# Advantech AE Technical Sharing Documentation

Date	2018 / 10 / 19	SR#	1-3584329961
Category	■ FAQ □ SOP	Related OS	N/A
Abstract	Notification: The new version mainboard of UNO-1372G-J		
Keyword	SIM card slot position changed		
Related Product	UNO-1372G-J

**ECOM-146522**

**Figure A.1 Connector & Switch Locations on MB(Top)**

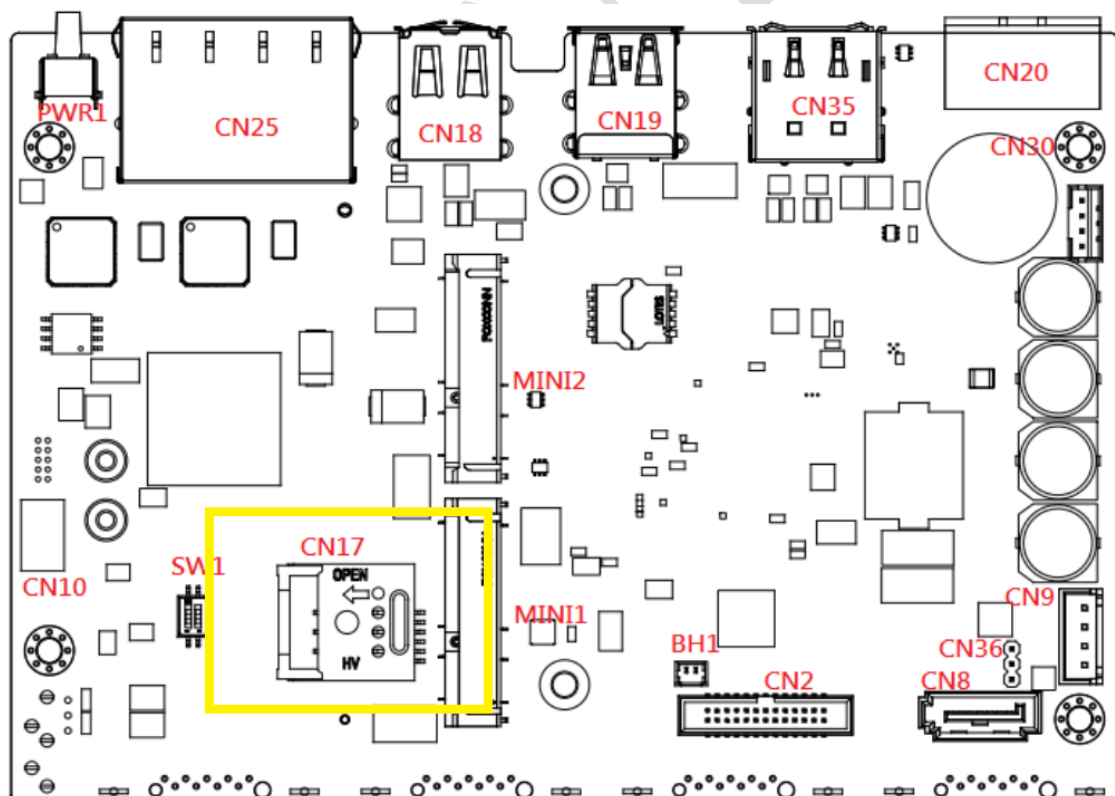
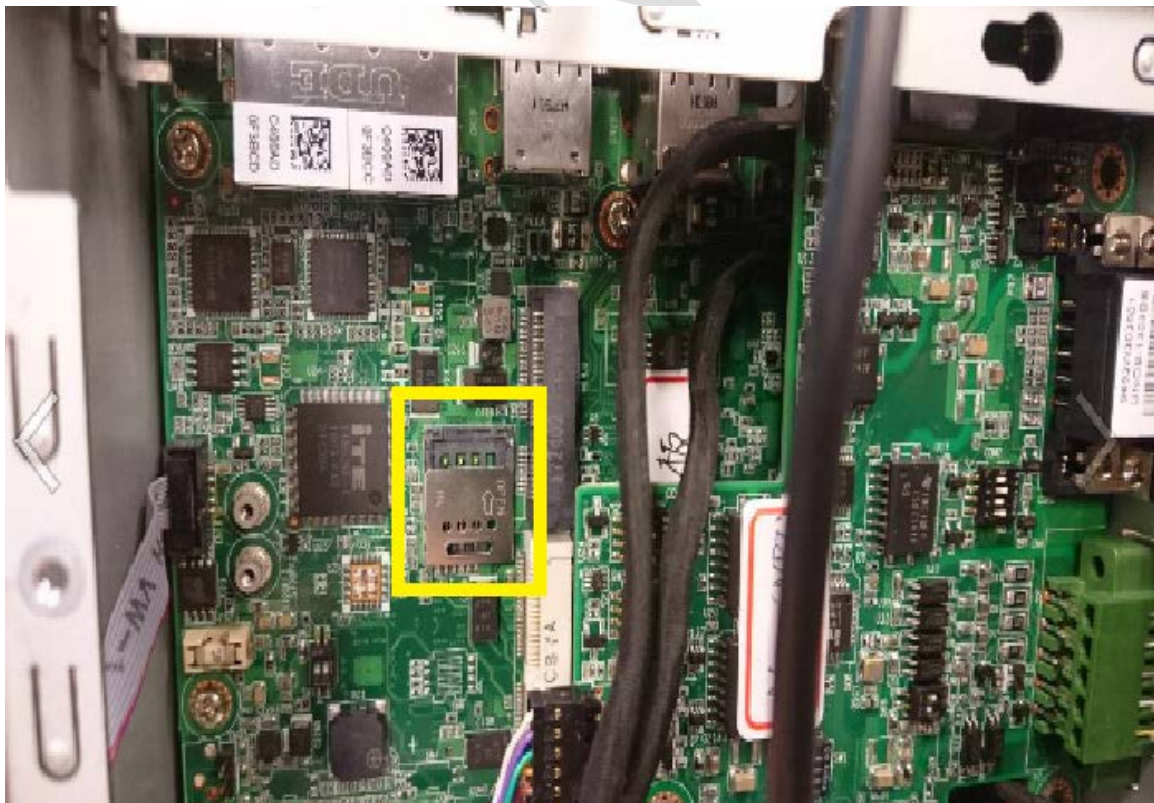
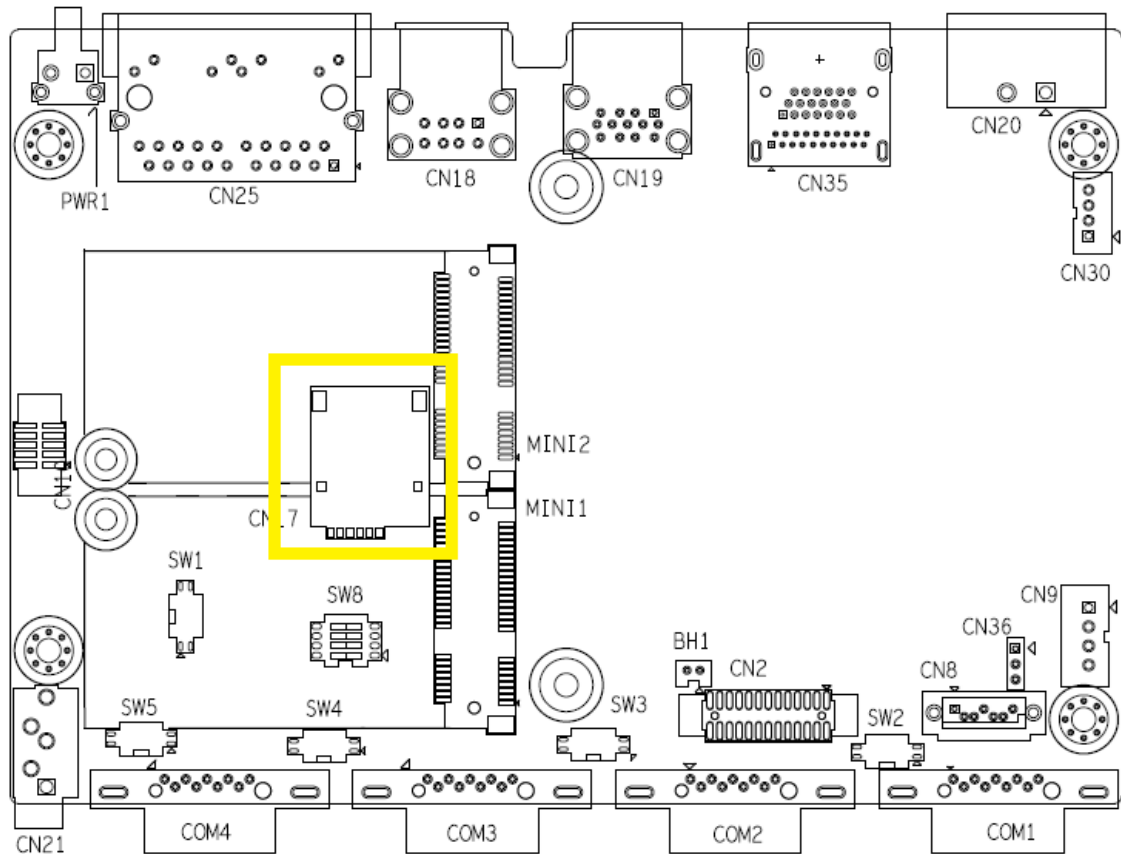
We are about to release an ECOM for changing motherboard to a new version.  
The SIM card slot position has been changed in the new version of motherboard.

1. The original mainboard position of the SIM slot.

2. The new version mainboard position of the SIM card slot.
